NOTICE OF MEETING

TO: Planning Commission
FROM: Ben Prchal, City Planner
AGENDA ITEM: Variance Requests - 9447 Stillwater Blvd.
REVIEWED BY: Ken Roberts, Planning Director

PROPOSED VARIANCES

AGENDA ITEM: Approve Engineering Design and Construction Standards Manual –
APRIL 2019 Revisions

WEST ELEVATION

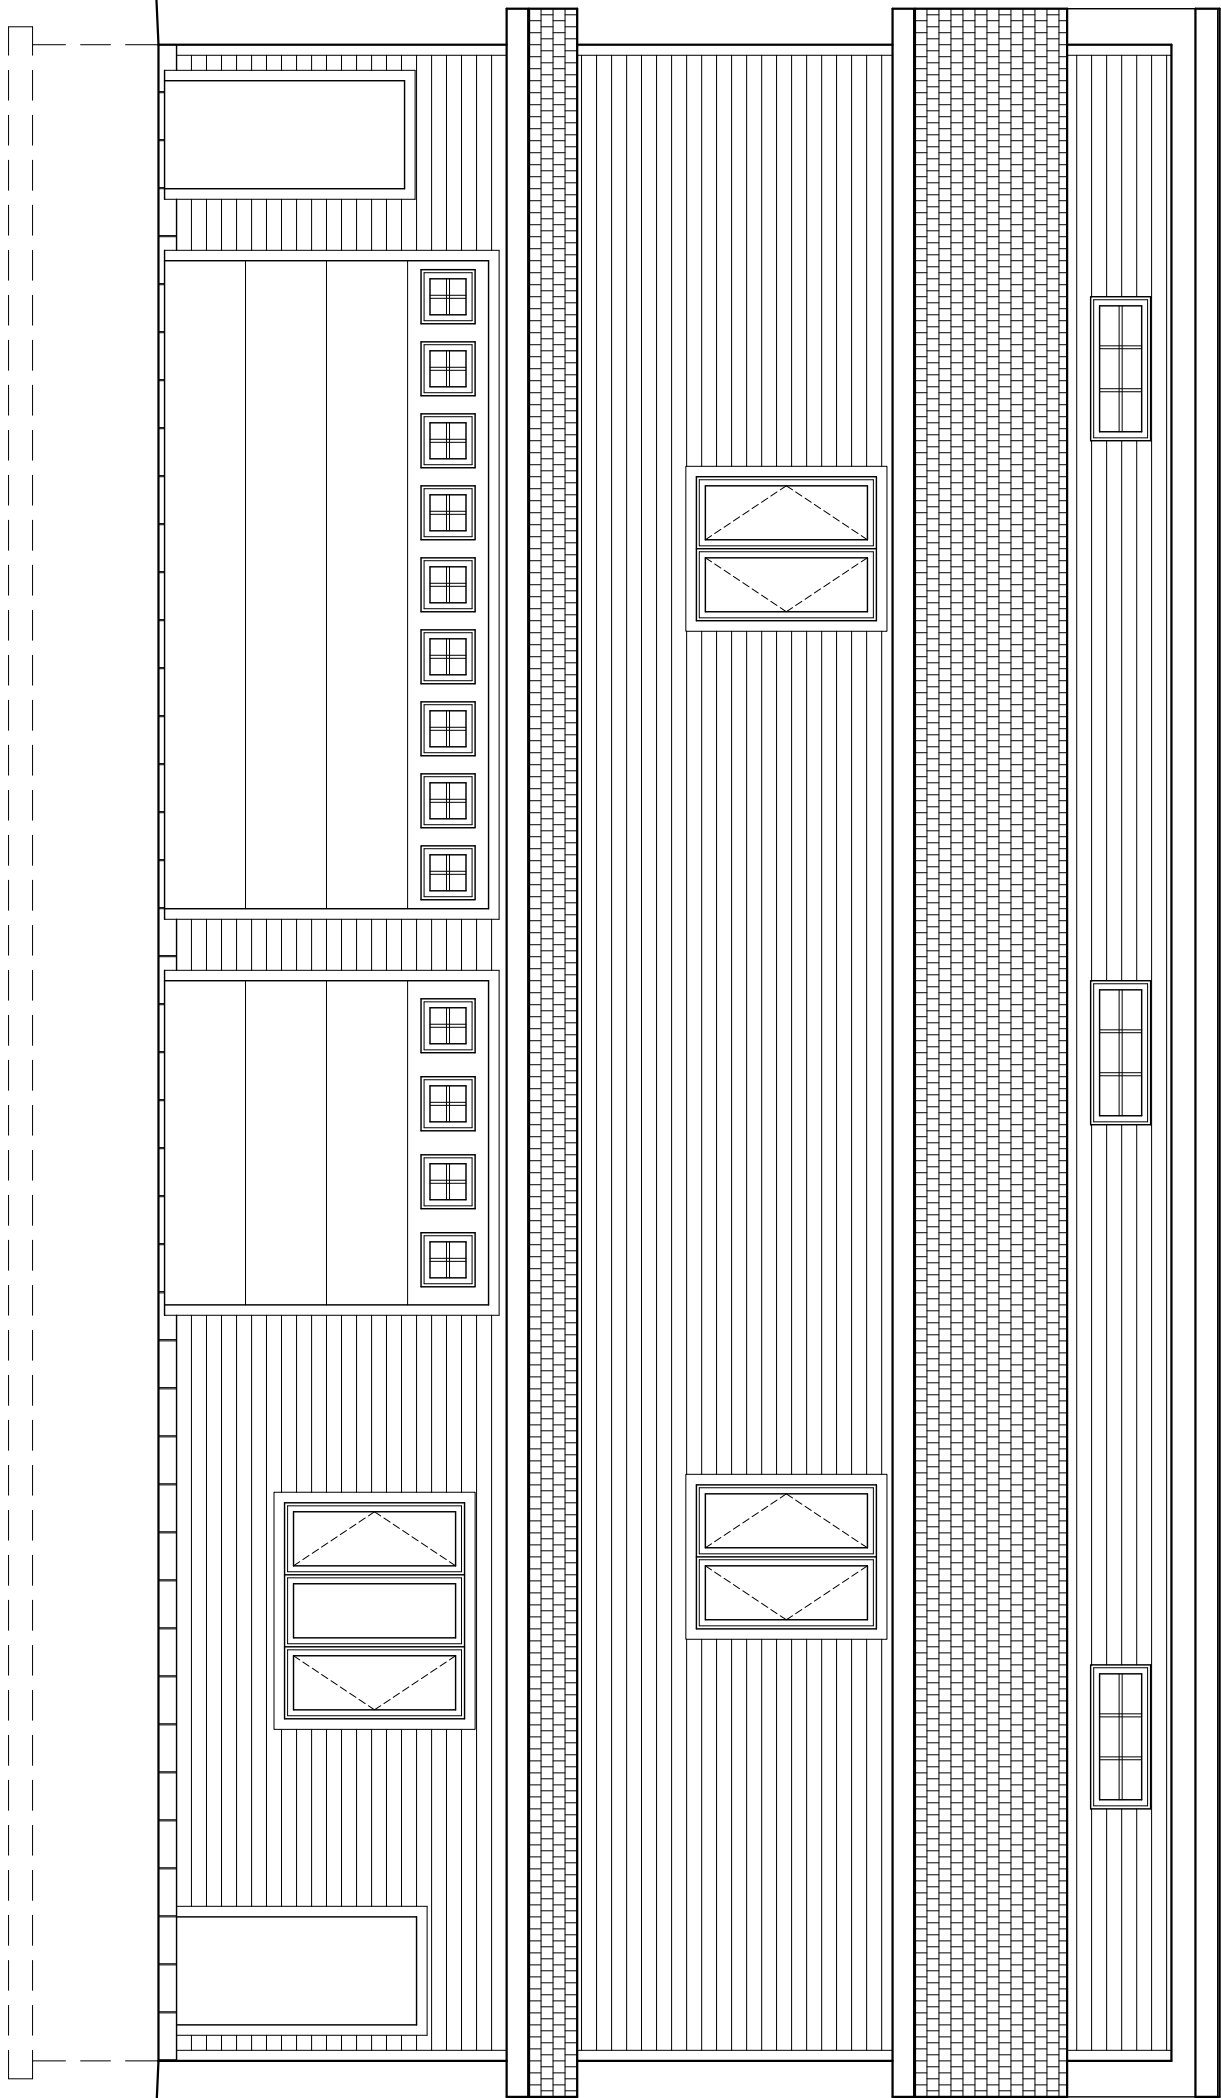
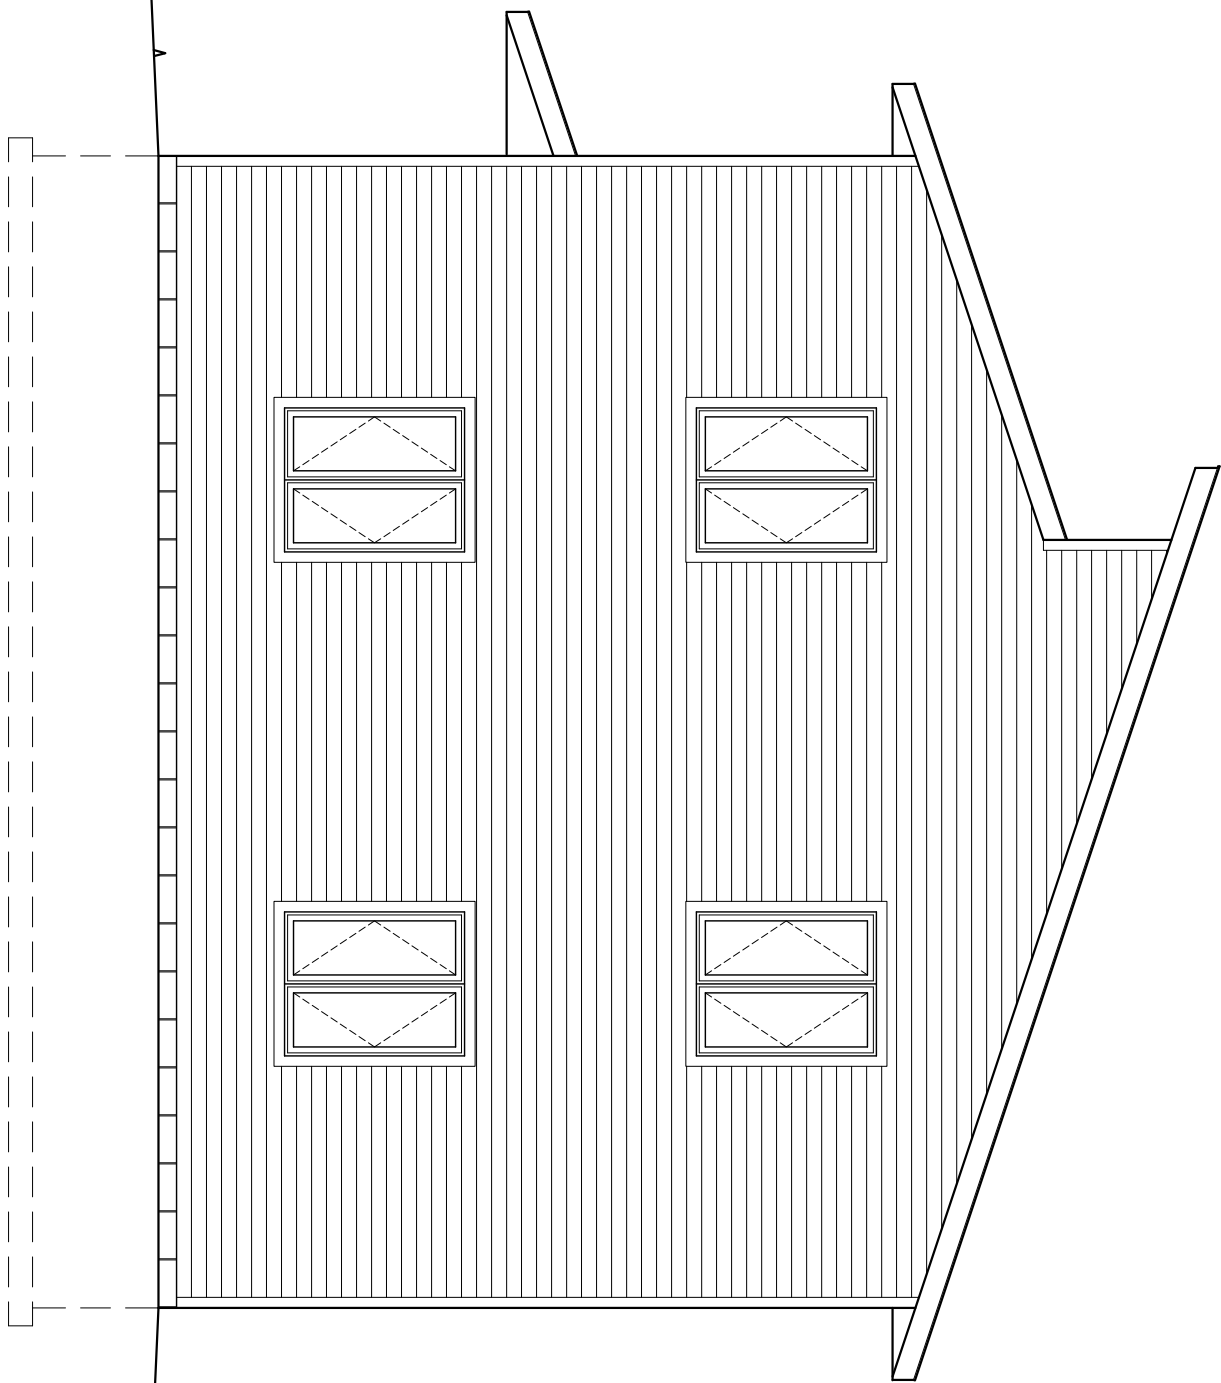
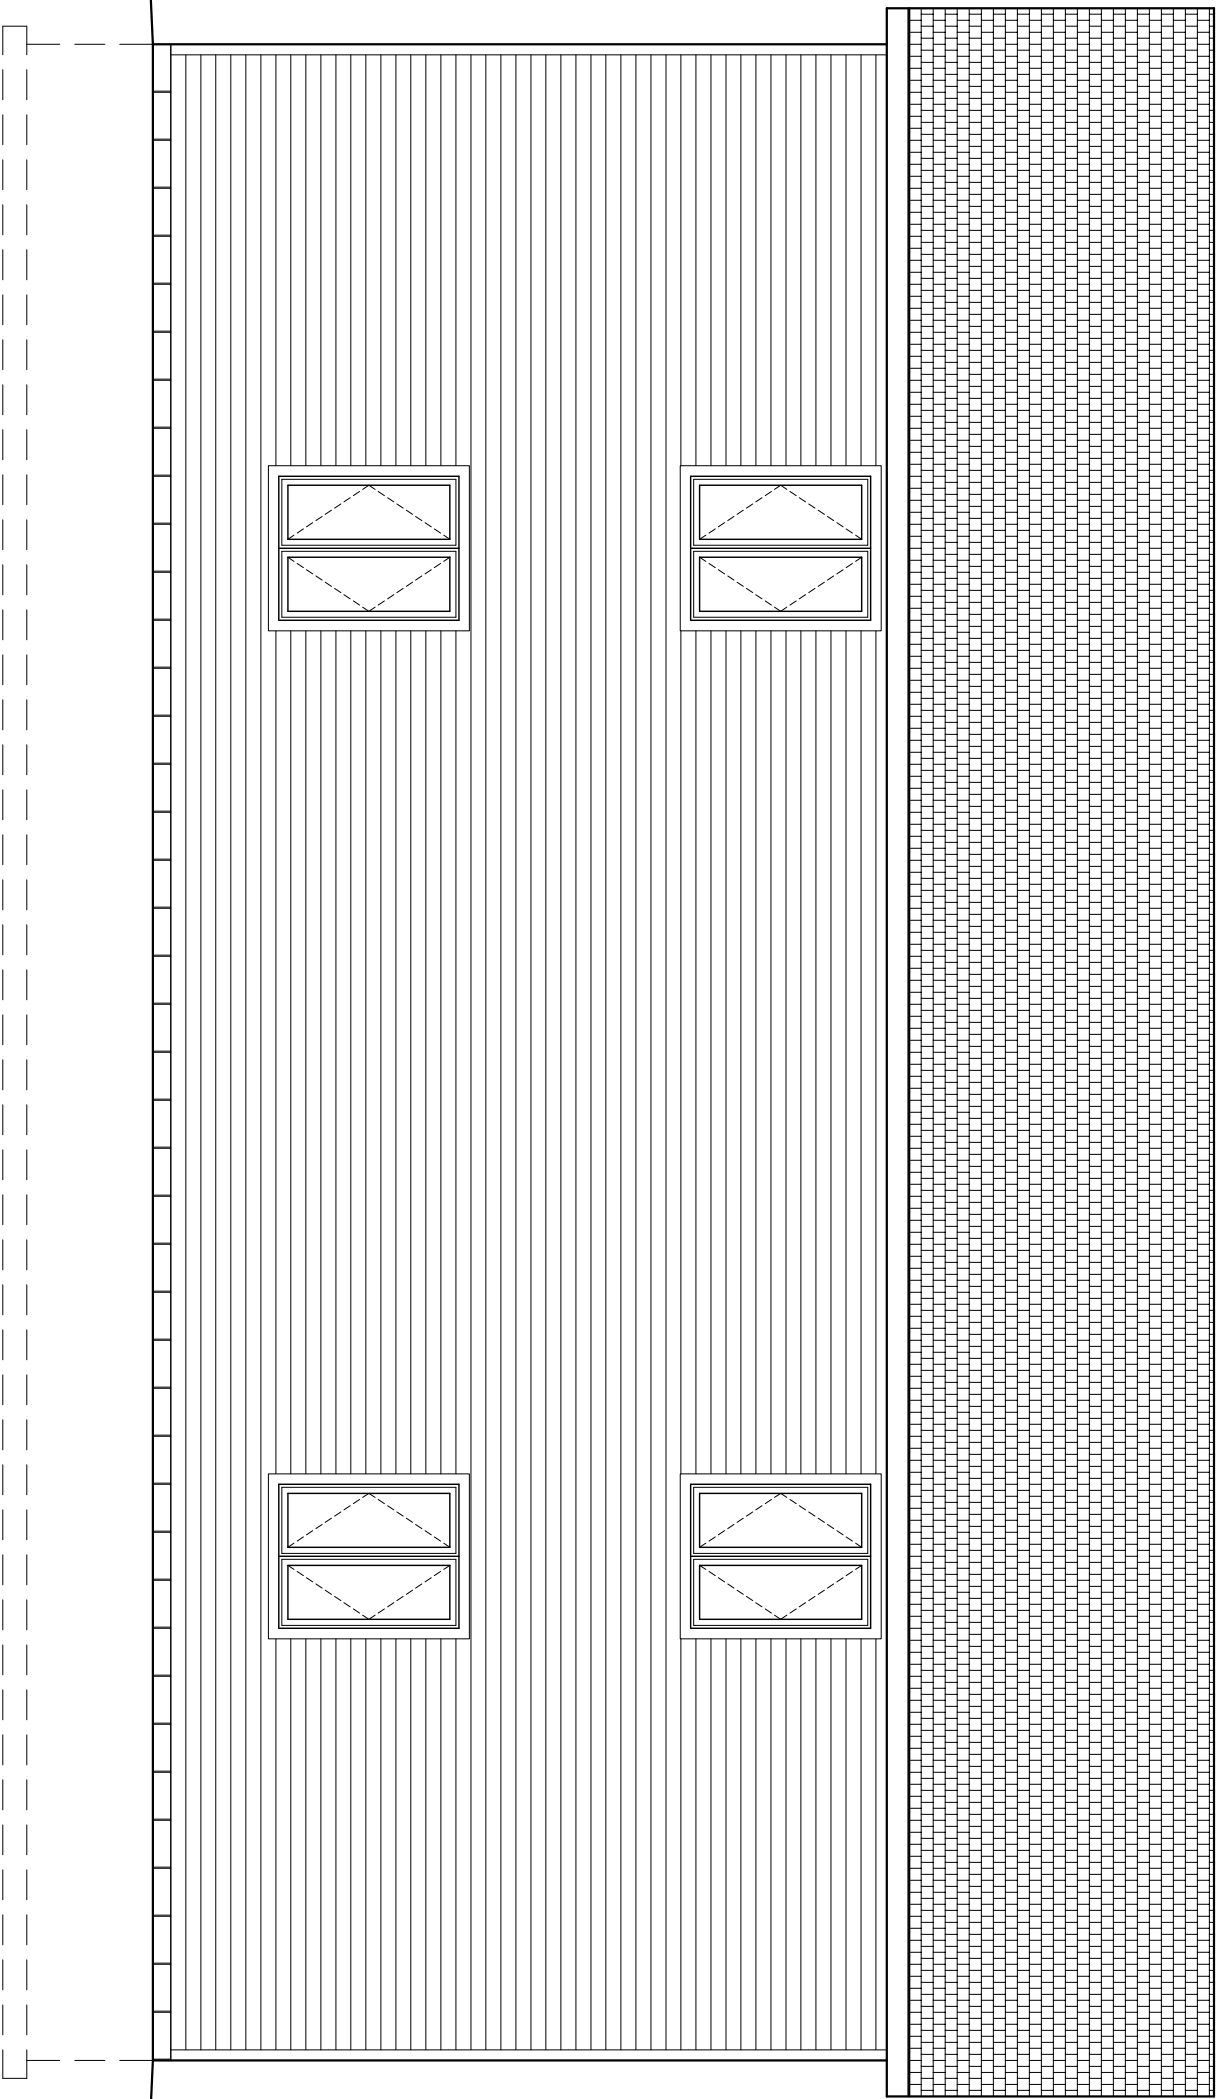
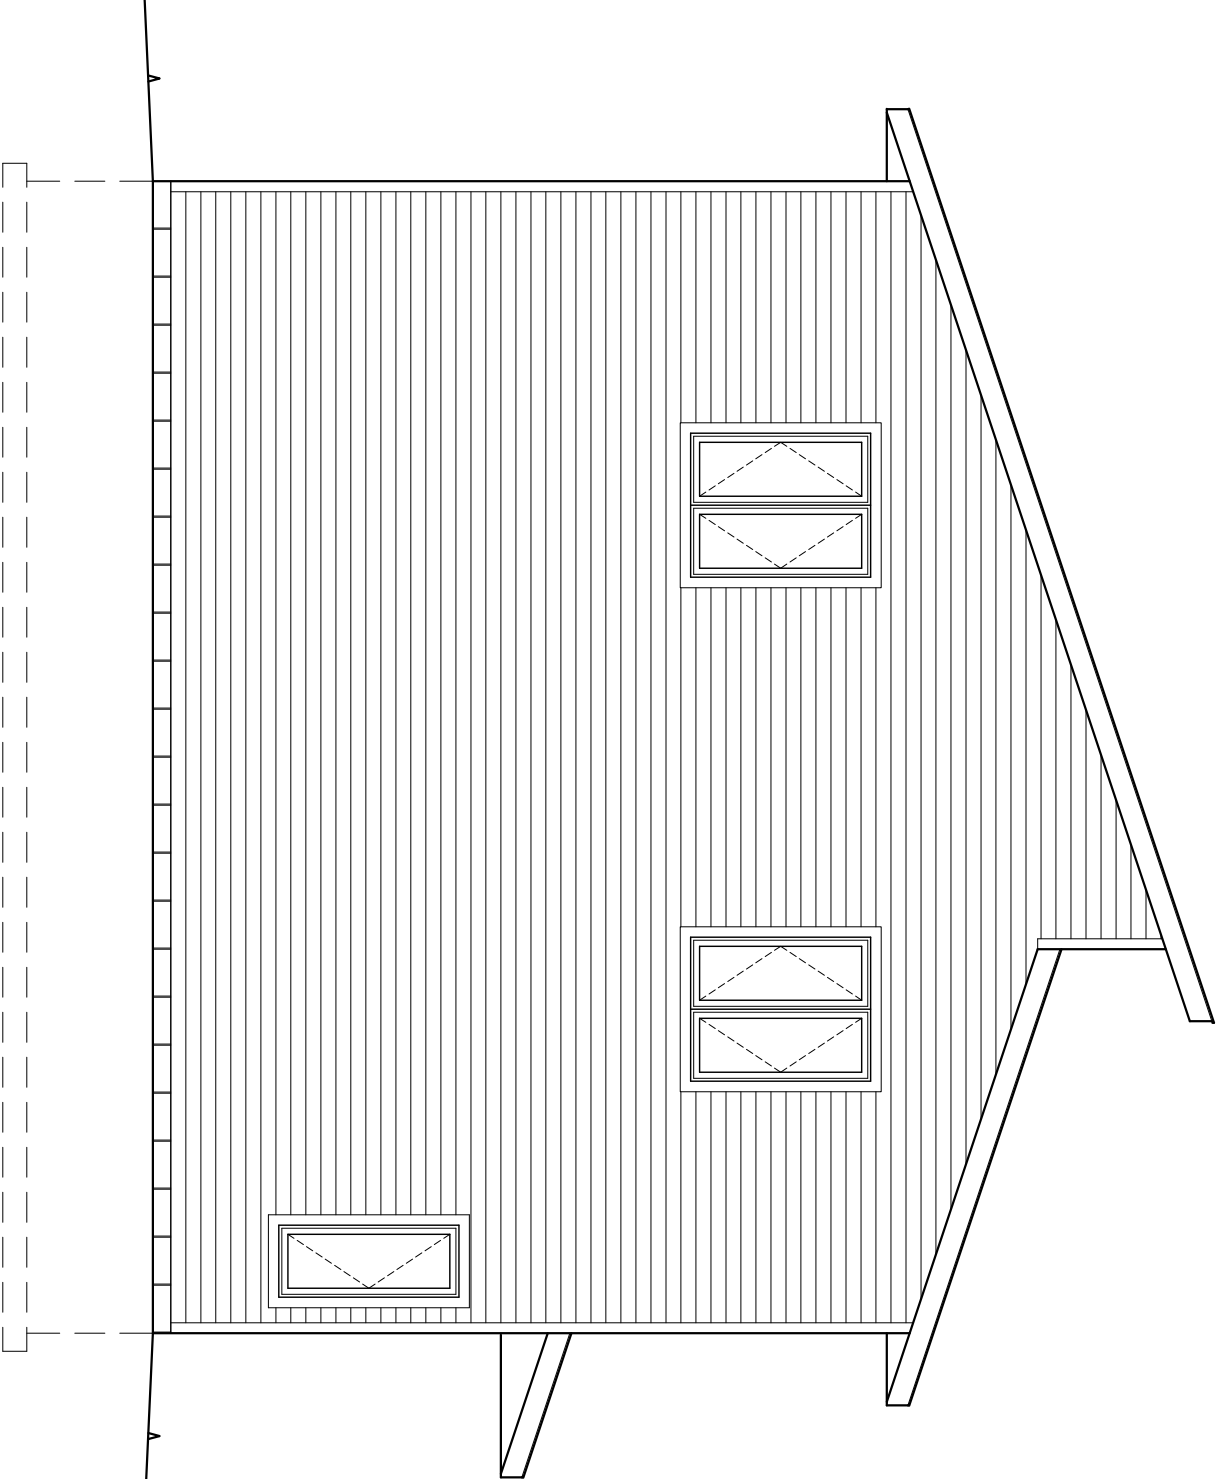
The important point here is that the applicant has designed the shed so that it would not exceed the height of the principle structure. With the home being 29½ ft. in height the accessory structure was designed at 29 ft. in height. However, the code also reads that accessory buildings cannot exceed 22 ft. in height. The current design exceeds the maximum height allowance by 7 ft. Because of this, a variance is being sought for the proposed height of the accessory structure.

When reviewing accessory building requests Staff has uses the “Building Height” definition as the standard for determining the height of structures. The diagram to the right lists out the different measure points that are listed out in the definition. If the height variance is denied for the applicant, there would be the option to seek out Washington County and consult with them on having the property reclassified as outlined in section 154.213. If that were to happen Staff does not necessarily see why the applicant would be restricted to the 22 ft. height requirement.

At this point Staff does not believe the request to have a structure taller than what is allowed meets the criteria for variance approval. However, the last sentence in section 154.406 does allow structures to exceed the 22 ft. height requirement with specifically listed items. If the Commission believes that the upper roof/window qualifies as a decorative attachment this could put the applicant in a more favorable position. If this is determined to be

the case then the highest point would be measured at a lower position which would bring all the other measurements down. Then the projection would have to be reduced down to 25 ft. Staff does believe there would be grounds to make this determination as the applicant has added this window to match the design of the home, constituting a “similar decoration.”

1. That the Applicant obtain all applicable permits including but not limited to a City building permit including a grading, erosion control, and storm water management plan approved by the City Engineer.
2. That the Applicant must reduce the height of the building to 22 ft. unless the property is reclassified to Agricultural. If reclassified, the applicant can increase the structures height to 25 ft.
3. If approved this variance approval is valid for 1 year and would expire on XXX. (date set after council approval)
4. One of the other smaller accessory buildings noted on the survey must be removed prior to the issuance of a building permit of the new accessory structure.
